ACCESSIBILITY ASSESSMENT

February 5, 2025

ADA TITLE II ASSESSMENT

Walterville Elementary School

Photos for Barrier ID: AX525895

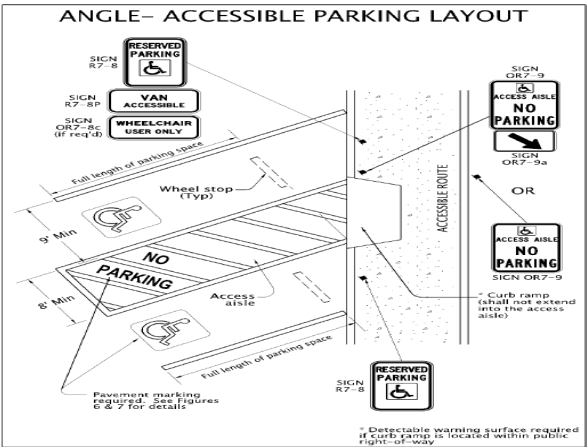
Assembly	Accessible Parking
Type	Parking Space - Car
ADA Standard	Oregon Revised Statutes 447.233-2(e) and 2(f); ADA 502.6
Barrier Detail	OREGON: Signage is not compliant for the standard accessible space.
Location Description	Accessible Parking Stall P1-A
Observed	Nov 20, 2024 by lina.sarikhani@bureauveritas.com
Site Conditions	The signage is mounted 54-1/2 inches above the paving.

Provide compliant signage for the standard accessible stall. Install signage showing the International Symbol of Accessibility (ISA) EITHER on a free-standing post mounted minimum 84" (+ or - 3") above the stall surface measured to the bottom of the parking sign OR on a building or pier mounted minimum 60" above the stall surface measured to the bottom of the parking sign. Where signage is located on a free-standing post, the post shall be located at the head of the stall, and 2' minimum from the centerline of the painted lines outlining the sides of the stall. Parking space identification signs shall include the International Symbol of Accessibility, and "Reserved Parking". Where the sign post is mounted on a raised surface which is higher than the stall pavement, the vertical measurement shall be from the stall pavement surface to the bottom of the sign.

Photos for Barrier ID: AX525899

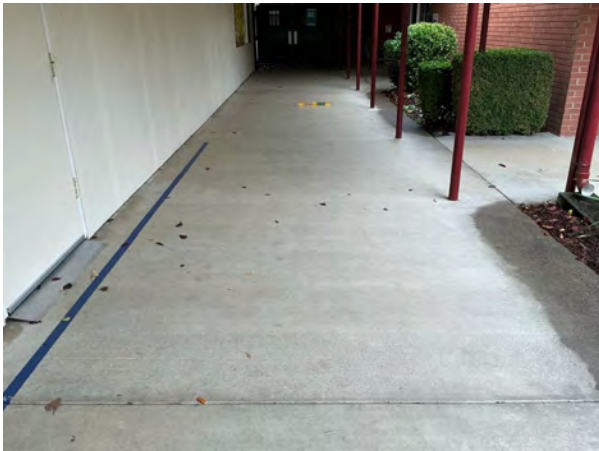
Assembly	Exterior Access Route
Type	Exterior Accessible Route
ADA Standard	403.3
Barrier Detail	The accessible route has cross slopes greater than 1:50 (2%).
Location Description	Accessible Route to Basketball & Playground
Observed	Nov 20, 2024 by lina.sarikhani@bureauveritas.com

The walkway should be graded to a maximum 1:50 (2%) cross slope. An accessible route has maximum 1:20 (5%) running slope and maximum 1:50 (2%) cross slope. [EXCEPTION: Cross slopes not exceeding 1:48 (2.08%) are permitted.] The clear width of walking surfaces shall be 36" minimum. [EXCEPTION: The clear width shall be permitted to be reduced to 32" minimum for a length of 24" maximum provided that reduced width segments are separated by segments that are 48" long minimum and 36" wide minimum.] Where grading to maximum running slope of 1:20 (5% running slope) is not possible, provide a compliant ramped surface within the walkway with maximum slope 1:12 (8.33%) and maximum ramp run rise of 6" without handrails. If a ramped surface with running slopes greater than 1:20 (5%) and maximum 1:12 (8.33%) rises more than 6", handrails are required. The cost estimate for this barrier removal is based on grading the running slope to maximum 1:20 (5%). The quantity and order of magnitude cost estimate provided for this barrier are limited to the extent of the area identified as non-compliant. Additional costs that may be associated with removal of the barrier are not included.

Photos for Barrier ID: AX525937

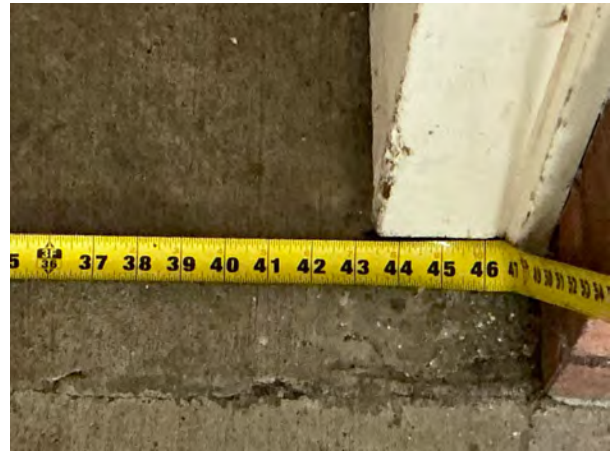
Assembly	Exterior Access Route
Type	Stairs
ADA Standard	505
Barrier Detail	Handrails are not compliant or are not provided.
Location Description	Cafeteria/Gym Stairs ST-1
Observed	Nov 20, 2024 by lina.sarikhani@bureauveritas.com

Photos for Barrier ID: AX525918

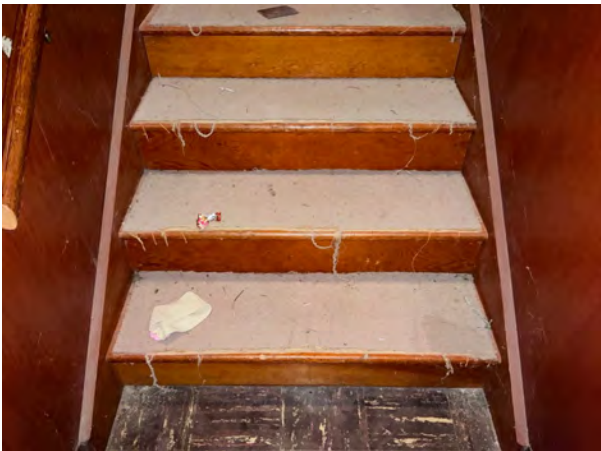
Assembly	Entrance to Building
Type	Building Entrance-Door
ADA Standard	305.2; 404.2
Barrier Detail	The maneuvering clearance at the accessible door is not level and clear.
Location Description	Classroom Doors
Observed	Nov 20, 2024 by lina.sarikhani@bureauveritas.com

Remove and replace the surface within the required maneuvering clearance area so that the surface is level and clear with maximum slope 1:48 (2.08%) in any direction. The required depth of the maneuvering clearance is 60" minimum. The required side clearance is 18" minimum on the latch side of the door. Maneuvering clearance shall extend the full width of the doorway and the required latch side clearance. Floor or ground space within the required maneuvering clearance shall be maximum 1:48 (2.08%) slope. Changes in level are not permitted.

Photos for Barrier ID: AX525932

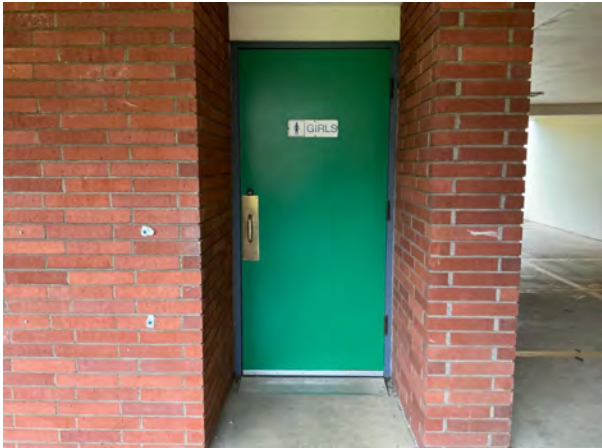
Assembly	Entrance to Building
Type	Building Entrance-Door
ADA Standard	Oregon Structural Specialty Code 1102.1.2.
Barrier Detail	
OREGON: The hinged accessible exterior door requires more than 8.5 pounds of pressure to operate	
Location Description	Girl's Restroom RR-3
Observed	Nov 20, 2024 by lina.sarikhani@bureauveritas.com
Site Conditions	The opening force is 12 pounds.

Adjust the closer or replace with an exterior door that requires no more 8.5 pounds of force for pushing or pulling the door open. This barrier must be removed in conjunction with barrier ID 525933. The opening force of doors along an accessible route shall be as follows: 1. Exterior doors: 8.5 pounds maximum (lbf) (37.8 N). 2. Interior doors: 5 pounds maximum (lbf) (22.2 N). 3. Stairway doors at pressurized stair enclosures: 15 pounds maximum (6.8 kg) at exterior doors. 4. Where environmental conditions require greater closing pressure, power-operated doors shall be used within the accessible route. [Exception: The force required to retract latch bolts or disengage other devices that hold the door or gate in a closed position shall not apply to panic hardware, delayed egress devices or fire-rated hardware.]

Photos for Barrier ID: AX525933

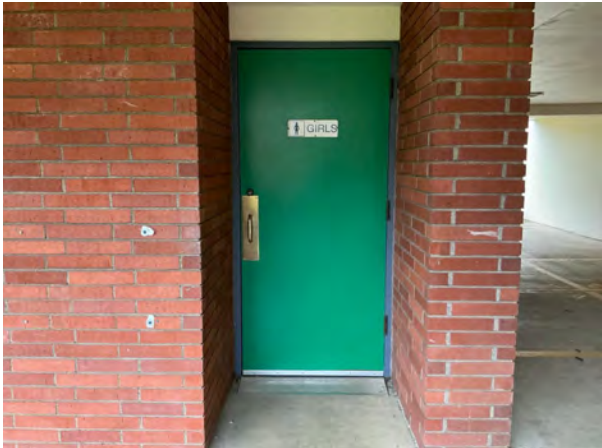
Assembly	Entrance to Building
Type	Building Entrance-Door
ADA Standard	305.2; 404.2
Barrier Detail	The maneuvering clearance at the accessible door is not level and clear.
Location Description	Girl's Restroom RR-3
Observed	Nov 20, 2024 by lina.sarikhani@bureauveritas.com

Remove and replace the surface within the required maneuvering clearance area so that the surface is level and clear with maximum slope 1:48 (2.08%) in any direction. The required depth of the maneuvering clearance is 60" minimum. The required side clearance is 18" minimum on the latch side of the door. Maneuvering clearance shall extend the full width of the doorway and the required latch side clearance. Floor or ground space within the required maneuvering clearance shall be maximum 1:48 (2.08%) slope. Changes in level are not permitted.

Photos for Barrier ID: AX525931

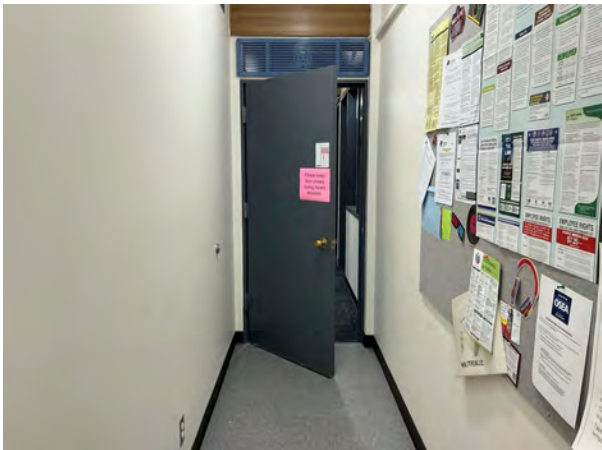
Assembly	Interior Access Route	
Type	Door	
ADA Standard	307.4, 404.2.3	
Barrier Detail	The door has less than 32" clear width.	
Location Description	Main Office Restrooms RR-1 & 2	
Observed	Nov 20, 2024 by lina.sarikhani@bureauveritas.com	
Site Conditions	The clear width of the doors is 25 inches.	
Width	25"	
Resolution	<p>Remove and replace with a door that has a minimum clear opening of 32". Door openings shall provide a clear width of 32" minimum. Clear openings of doorways with swinging doors shall be measured between the face of the door and the stop, with the door open 90 degrees. Openings more than 24" deep shall provide a clear opening of 36" minimum. There shall be no projections into the required clear opening width lower than 34" above the finish floor or ground. Projections into the clear opening width between 34" and 80" above the finish floor or ground shall not exceed 4". [EXCEPTIONS: 1. In alterations, a projection of 5/8" maximum into the required clear width shall be permitted for the latch side stop. 2. Door closers and door stops shall be permitted to be 78" minimum above the finish floor or ground.]</p>

Photos for Barrier ID: AX525901

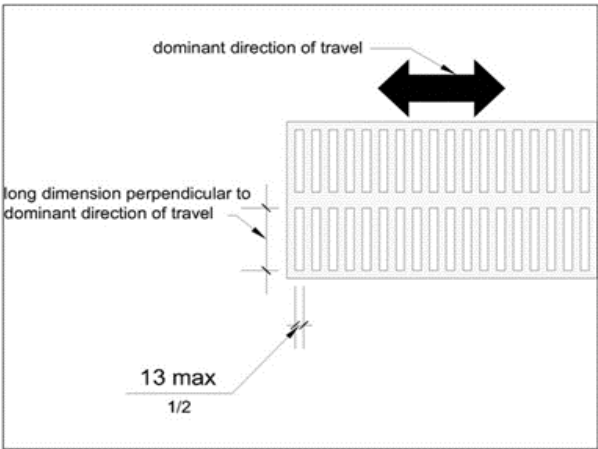
Assembly	Exterior Access Route
Type	Exterior Accessible Route
ADA Standard	R204, R302.7.3
Barrier Detail	PROWAG - The opening in the drain or grate is more than 1/2".
Location Description	Accessible Route to Playground
Observed	Nov 20, 2024 by lina.sarikhani@bureauveritas.com

Remove and replace with an ADA compliant grate that has openings no greater than 1/2" wide in one direction, and elongated openings shall be placed so that the long dimension is perpendicular to the dominant direction of travel. Openings in floor or ground surfaces shall not allow passage of a sphere more than 1/2" (13 mm) diameter'. Elongated openings shall be placed so that the long dimension is perpendicular to the dominant direction of travel.

Photos for Barrier ID: AX525940

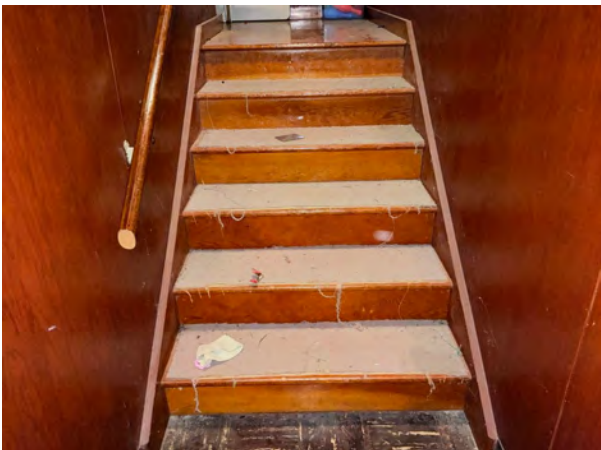
Assembly	Restroom
Type	Restroom/Bathroom - Lavatory
ADA Standard	213.3.4, 606.5
Barrier Detail	Pipes are not insulated.
Location Description	Girl's Restroom RR-3
Observed	Nov 20, 2024 by lina.sarikhani@bureauveritas.com
Site Conditions	The lavatory drainpipe and water supply lines are not insulated.

Insulate water supply and drain pipes under the accessible lavatory. Water supply and drain pipes under lavatories and sinks shall be insulated or otherwise configured to protect against contact. Pipes under lavatories and sinks shall be free from sharp or abrasive surfaces. A minimum of one lavatory in a multi-lavatory restroom shall be a compliant lavatory.

Photos for Barrier ID: AX525934

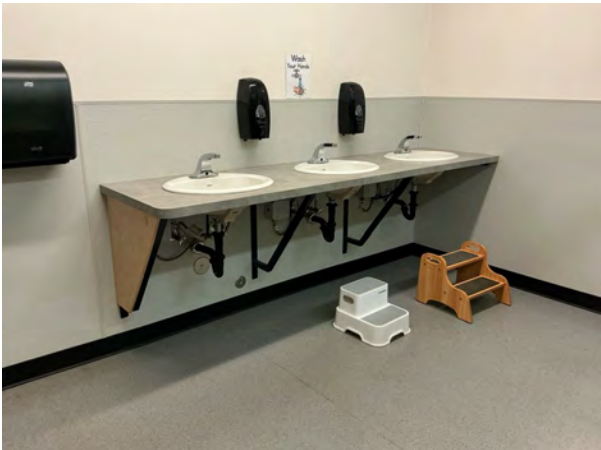
Assembly	Restroom
Type	Restroom/Bathroom-Toilet Stall
ADA Standard	309, 404.2.7, 604.5.1, 604.6, 604.7, 604.8.1.1, 604.8.1.2, 604.8.1.5, 604.9, 609.3
Barrier Detail	A wheelchair stall is not provided in a multi-user restroom.
Location Description	Girl's Restroom RR-3
Observed	Nov 20, 2024 by lina.sarikhani@bureauveritas.com
Site Conditions	Four toilet stalls exist with no wheelchair accessible stall provided.
